Service Bulletin 69

Subject: Seat Belt Anchor Points

Applicability: All GlaStar and Sportsman Aircraft

Figure 1

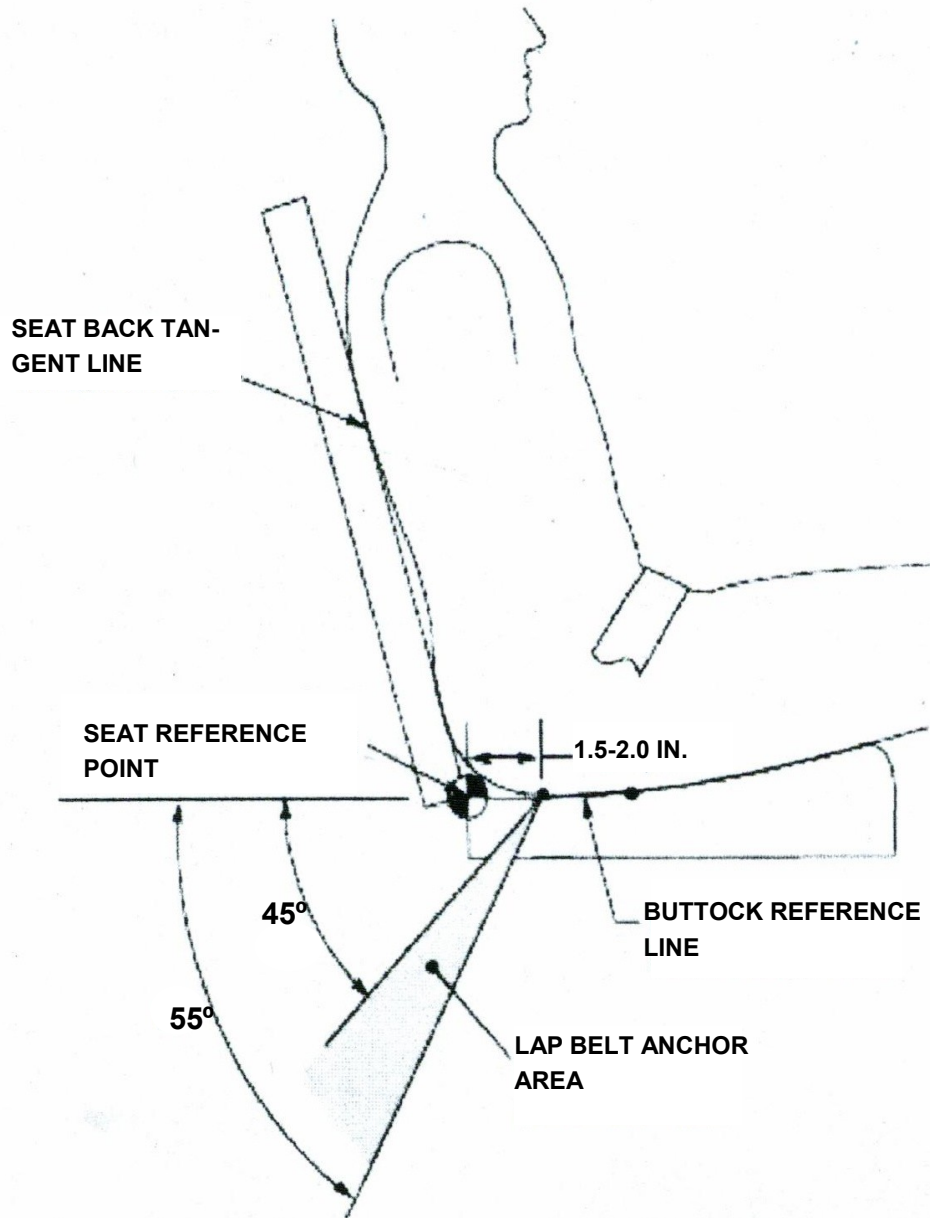
FAA Advisory Circular AC21-34 Shoulder Harness - Seat Belt Installations provides information and guidance for installation of shoulder harness and safety belt restraint systems. AC21-34 recommends that lap belt anchor points mount so as to maintain an angular range of 45° - 55° for all seat range positions. (See Figure 1 on the next page)

As currently configured, the GlaStar / Sportsman lap belt anchors can fall outside of the recommended angular range, especially when the seat backs are in the mid to aft locations. (See photos in appendix.)

To bring GlaStar / Sportsman lap belt anchor points to within the suggested angular range, Glasair Aviation recently relocated the lap belt anchor points on production cage assemblies.

For existing GlaStar / Sportsman aircraft, Glasair Aviation has developed a Retrofit Kit to re-locate the lap belt anchor points to new production specifications. New, longer seat belts are required to match the new anchor point locations.
